**[Docket No. FAA-2024-0769; Project Identifier AD-2023-00556-T; Amendment 39-22815; AD 2024-16-09]**

### **Airworthiness Directives; The Boeing Company Airplanes**

Final rule.

**Figure 1 to Paragraph (h)(3)—Cap Sealing Dimensions (all Dimensions are in Inches)**

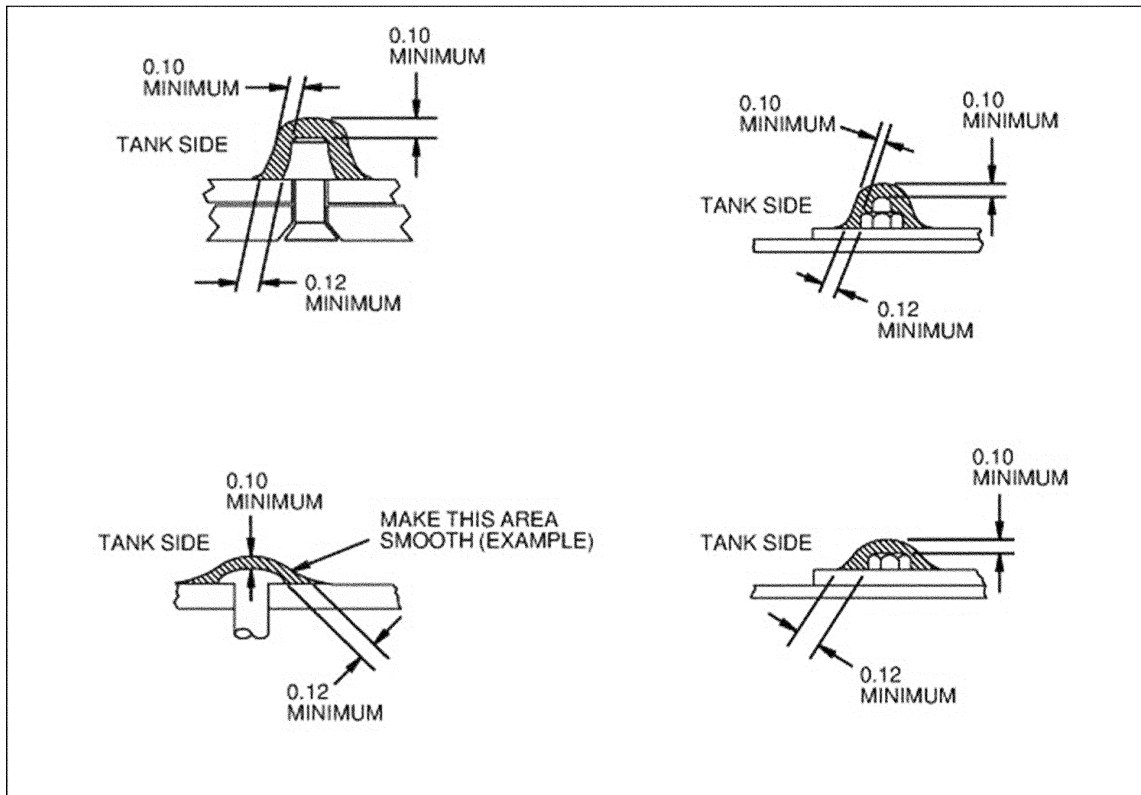
Boeing requested that paragraph (h)(3) of the proposed AD be clarified to specify that only the fuel tank side of fastener locations that penetrate the fuel tank boundary require cap seal dimensions to

meet the dimensions given in Figure 1 to paragraph (h)(3) of the proposed AD. Boeing stated that the service information referenced in Boeing Alert Requirements Bulletin 777-53A0100 RB, dated March 16, 2023, contain instructions for applying cap seals to fasteners that penetrate a fuel tank boundary and fasteners that do not penetrate a fuel tank boundary. Boeing added that for fasteners that do not penetrate a fuel tank boundary, fastener sealing is used as a pressure seal to help mitigate corrosion and have sealing specifications that include minimum thickness requirements less than the amount shown in paragraph (h)(3) of the proposed AD that are acceptable for their intended function outside of the fuel tank. Boeing stated that for fasteners that penetrate the fuel tank, the cap seals on the interior side of the fuel tank act as a primary fuel seal, providing fault tolerance against electromagnetic effects (electrical fault currents and lightning currents), and are also cap sealed on the exterior side for corrosion prevention.

Boeing concluded that only the cap seals on the interior side of the fuel tank require the dimensions specified in Figure 1 of paragraph (h)(3) of the proposed AD to perform their intended function, which is consistent with the labels shown in Figure 1 of paragraph (h)(3) of the proposed AD. Boeing recommended replacing the text “applying a cap seal (sealant) to a fastener, fastener head, and fastener threads and collars, for this AD, during application of any cap seal to a fastener, fastener head, or fastener threads and collars” with the text “applying a cap seal (sealant) to a fastener location that penetrates the fuel tank boundary, for this AD, during application of any cap seal to a fastener, fastener head, or fastener threads and collars inside the fuel tank.”

Boeing requested that the FAA add a note to paragraph (h)(3) of the proposed AD to refer to Boeing Model 777 Aircraft Maintenance Manual (AMM) section 28-11-00 as an acceptable cap sealing

procedure to accomplish the actions required in that paragraph. Boeing stated it has received numerous queries from operators on Figure 1 to paragraph (h)(4) of AD 2023-17-14, which is identical to Figure 1 to paragraph (h)(3) of the proposed AD. Operators have asked whether Boeing Model 777 AMM section 28-11-00 would be an acceptable procedure for accomplishing the requirements of paragraph (h)(4) of AD 2023-17-14. Boeing stated it believes that AMM 28-11-00 is an acceptable procedure for performing cap sealing inside the fuel tank because the AMM is the source material for the contents in Figure 1 to paragraph (h)(3) of the proposed AD and contains the same minimum seal thickness dimensions as shown in Figure 1.

The FAA agrees to clarify paragraph (h)(3) of this AD for the reasons provided by the commenter. Locations that do not penetrate the fuel tank boundary do not require the same sealant application procedures. The FAA has added the text “inside the fuel tank” to paragraph (h)(3) of this AD. However, the FAA did not replace the text “to a fastener, fastener head, and fastener threads and collars” with the text “to a fastener location that penetrates the fuel tank boundary,” as recommended by the commenter, because the text “to a fastener, fastener head, and fastener threads and collars inside the fuel tank” better aligns with the language within the service information.

The FAA agrees. Boeing 777 AMM 28-11-00 meets the sealant requirements of Figure 1 to paragraph (h)(3) of this AD. As such, it would be an acceptable procedure to follow when sealing inside the fuel tank in accordance with paragraph (h)(3) of this AD. The FAA has added a note to paragraph (h)(3) of this AD accordingly.

(3) Where any service information referenced in Boeing Alert Requirements Bulletin 777-53A0100 RB, dated March 16, 2023, specifies applying a cap seal (sealant) to a fastener, fastener head, and fastener threads and collars inside the fuel tank, for this AD, during application of any cap seal to a fastener, fastener head, or fastener threads and collars inside the fuel tank, the cap seal must be applied using a cap sealing procedure with thickness greater than or equal to the dimensions given in Figure 1 to paragraph (h)(3) of this AD.

**Note 4 to paragraph (h)(3):** Guidance on an acceptable cap sealing procedure for accomplishing the actions required by paragraph (h)(3) of this AD can be found in Boeing Model 777 Aircraft Maintenance Manual (AMM) section 28-11-00.
